Notice of Allowability	Application No.	Applicant(s)	
	10/700,703	HANKS, D'ANNE BEUKELAER	
	Examiner Jinhee J. Lee	Art Unit 2831

EXAMINER'S AMENDMENT

FIG. 1

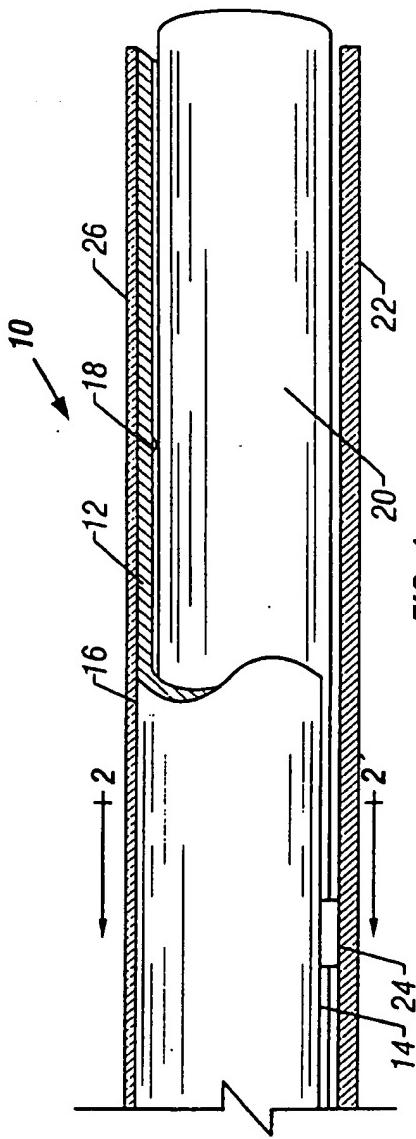
4. Add Chassis on drawing as shown in proposed drawings attached.

5. Add the item number to the Chassis added to the proposed drawing attached.
